Planning Commission Staff Report

Project Type: Amended Site Development Plan

Description: **YaYa's Euro Bistro (ASDP)** An Amended Site Development Plan, Landscape Plan, Architectural Elevations and Architect's Statement of Design for a 2 acre tract of land located southwest of the intersection of Olive Blvd and Chesterfield Pkwy.

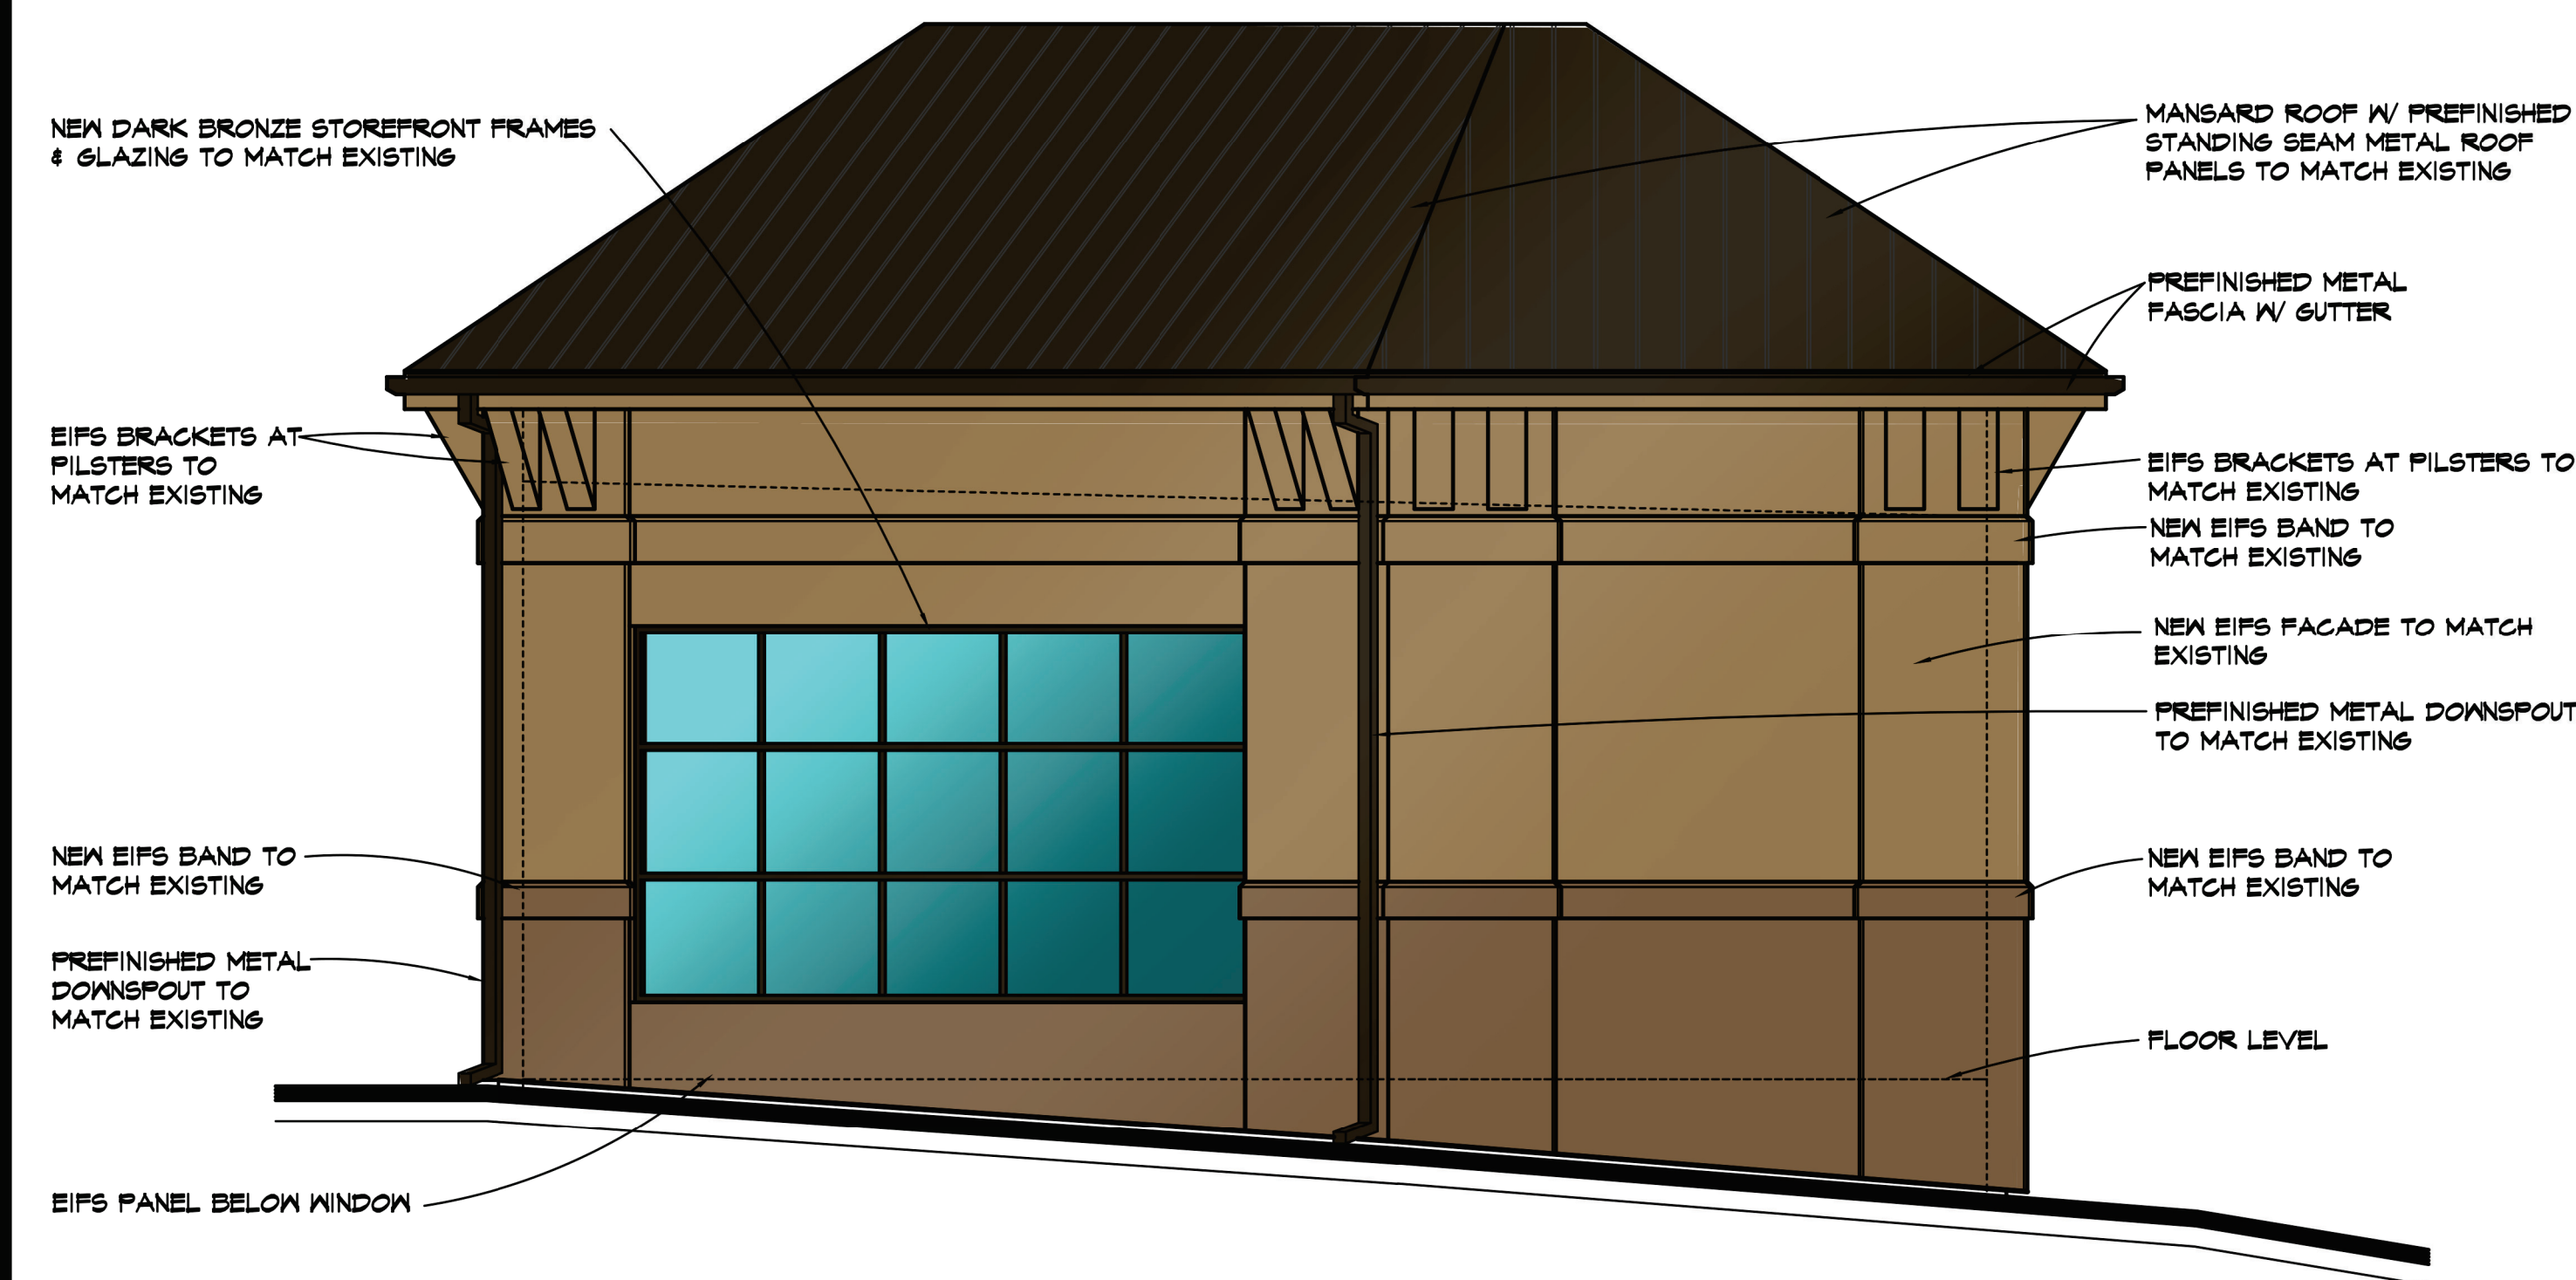
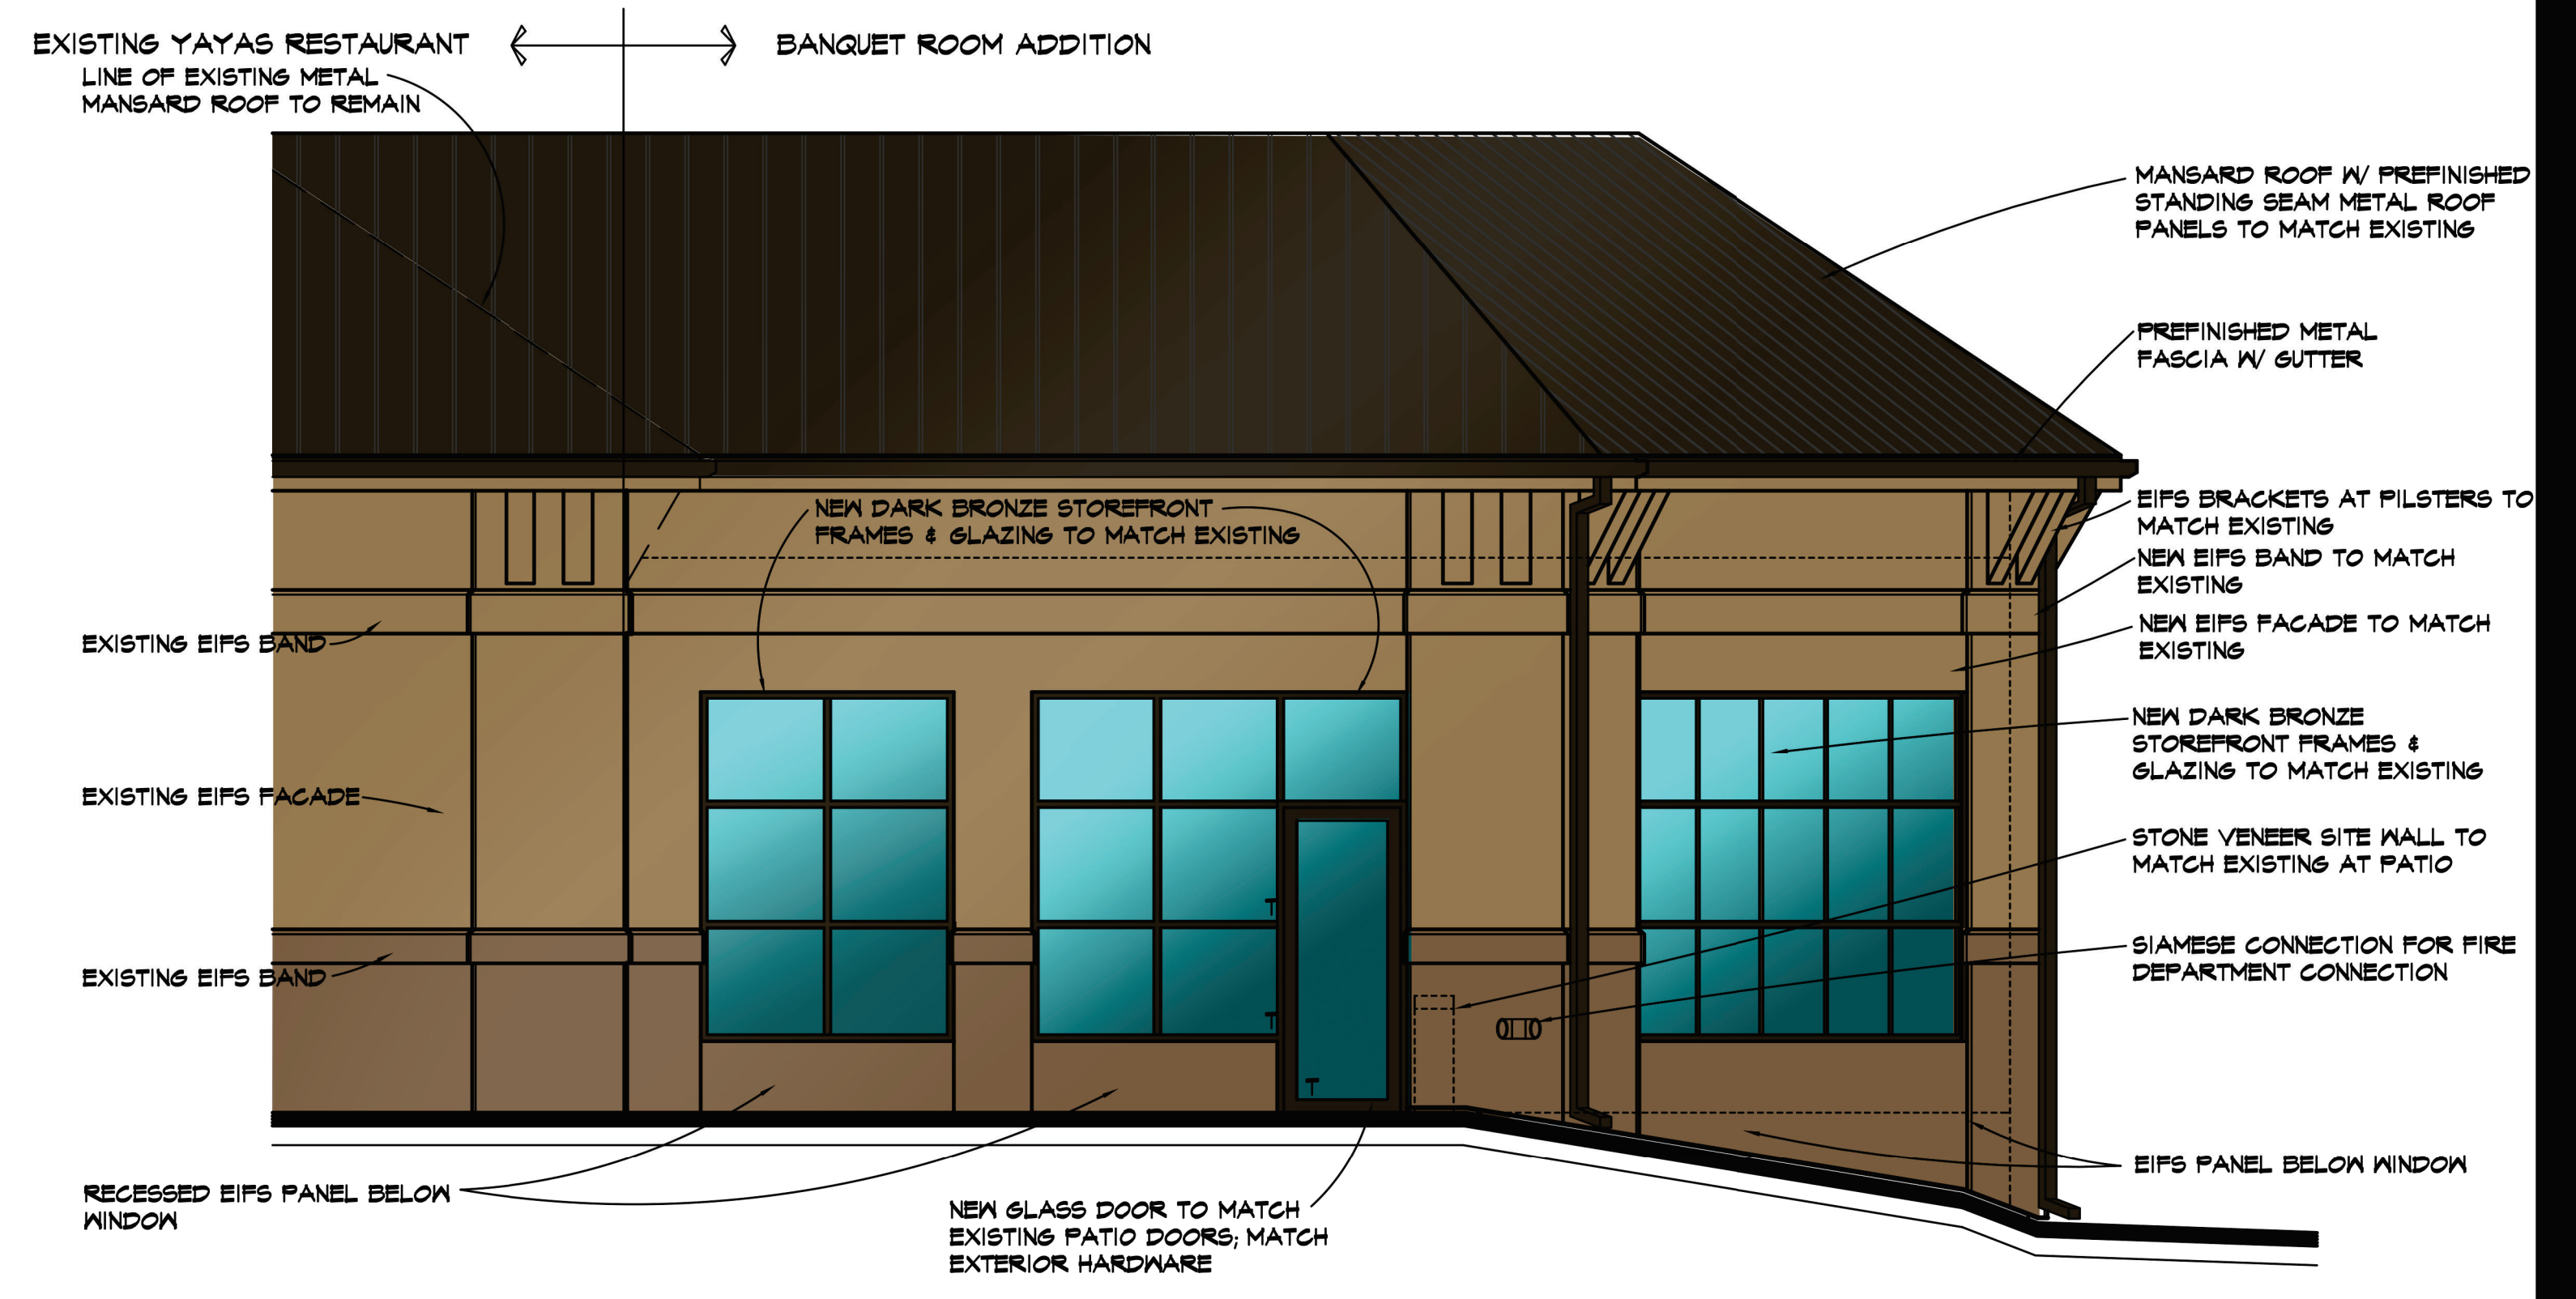
The project was reviewed by the Architectural Review Board on Thursday October 11th, 2018. At that time, the Board made a motion and seconded the motion to forward the project to the Planning Commission as presented, with the following conditions:

- The proposed addition should continue the darker EIFS color and banding around the base of the addition similar to the existing building.
- The proposed addition should incorporate elements of the mansard roof, pilasters, and brackets similar to the existing building.

Both of the ARB conditions were fulfilled. Figure 7 depicts the front of the building with the incorporated elements of the mansard roof, pilasters, and brackets similar to the existing building along with the darker EIFS color banding continuing around the base of the building. Figure 8 is the rear.
